**PLANNING APPROVAL &  
SIDEWALK WAIVER STAFF REPORT****Date: December 1, 2016****NAME**

**LOCATION**7078 Bruns Drive  
(Northeast corner of Bruns Drive and Cody Road)**CITY COUNCIL  
DISTRICT**

Planning Approval to allow an indoor shooting range/firearms training facility, in a B-3, Community Business District; and a Sidewalk Waiver approval to waive construction of sidewalks along Cody Road.

# SITE PLAN

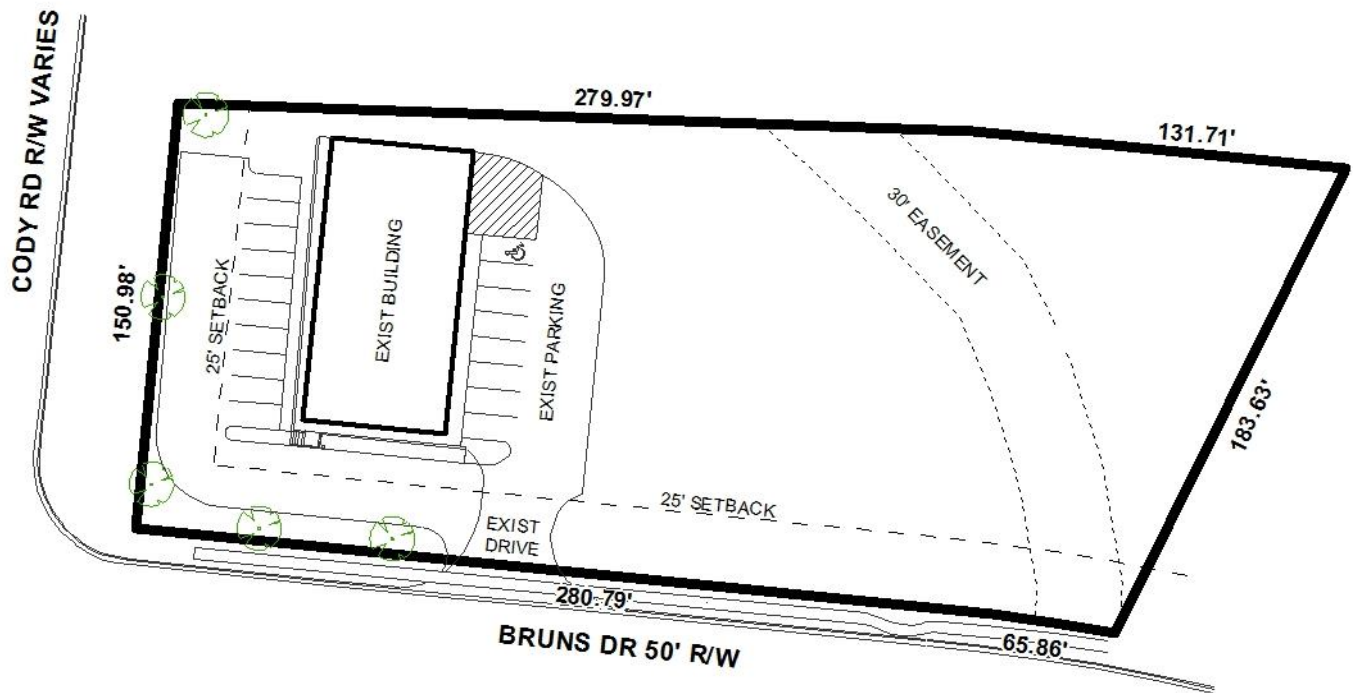
The applicant is also proposing additional parking between the existing building and Cody Road to accommodate the proposed use. The proposed use requires that 17 parking spaces be provided on site. The site plan illustrates that eighteen (18) 9'x18' parking spaces will be provided on the property, thus, reflecting compliance with the requirements of the Zoning Ordinance. It should also be noted that the access drive and aisle widths provide a sufficient distance for the accessibility and maneuverability of vehicles throughout the site; however, the applicant should ensure that the turnaround located on the West side of the structure provides a sufficient depth to allow vehicles to maneuver in and out of the parking spaces safely.

As it pertains to landscaping and tree planting requirements, the site plan indicates that 3 new heritage trees will be planted along Cody Road and that 2 new heritage trees will be planted along Bruns Drive; however there is a deficit in the number of frontage overstory trees, and perimeter overstory and understory trees required for the site. Per Section 64-4.E.3.a.2. of the Zoning Ordinance, one (1) overstory tree is required for every thirty feet of frontage. Since there are two frontages, Cody Road would require 5 new overstory tree plantings and Bruns Drive will require 11 new overstory tree plantings. Currently, there is a deficit of 11 frontage trees on site. It should also be noted that Live Oak trees are required as frontage overstory trees if the tree plantings are within 15' of overhead power lines.

Furthermore, the site plan indicates that two 24" Oak trees will be removed from the site in order to provide a 24' drive aisle width along the southern edge of the existing structure; nevertheless, it should be noted that the removal of Live Oak trees 24" and over will require the obtainment of tree permits. The applicant has provided a note (Note 7) on the site plan reflecting this requirement.

The location and dimensions of the existing and/or proposed HVAC mechanical equipment for the proposed indoor shooting range/firearms training facility building is not illustrated on the site plan. The site plan should be revised to indicate the location, height and size of the HVAC mechanical equipment (i.e. HVAC units, generators, etc.) in compliance with Section 64-4.D.11 of the Zoning Ordinance.

Note 5, regarding tree preservation and protection, should be revised to correctly reflect compliance with State Act 2015-116 and City Code Chapters 57 and 64. Additionally, Note 6, regarding Fire Department compliance, should be revised to reflect current code compliance regulations with the 2012 International Fire Code. It also appears that the note numbering is numbered incorrectly and should be revised for clarity and to reflect a sequential order.

Finally, the site plan shows an existing sign partially within the right-of-way for Cody Road. Research by staff shows that the sign is an "off-premise" sign for the elder care facility located at the Eastern terminus of Bruns Drive. This existing sign may prevent the proposed business on this site from being able to have a freestanding sign.

- 1) Submittal of a sealed letter from a licensed engineer to ensure that the structure will be properly sound-proofed at time of submittal for permits;

- 2) Placement of a note stating that the site will be in compliance with Section 64-6.A.3 of the Zoning Ordinance;
- 3) Revision of the tree planting calculations to correctly indicate the required number of overstory and understory trees needed on site;

- 4) Revision of the site plan to indicate the location, height and size of the proposed HVAC mechanical equipment;
- 5) Revision of Note 5 to comply with current State and Local laws as it pertains to tree preservation and protection;

- 6) Revision of Note 6 to comply with the current 2012 International Fire Code;
- 7) Revision of the site plan to indicate the correct numbering sequence in the *Planning Review Notes* section; and
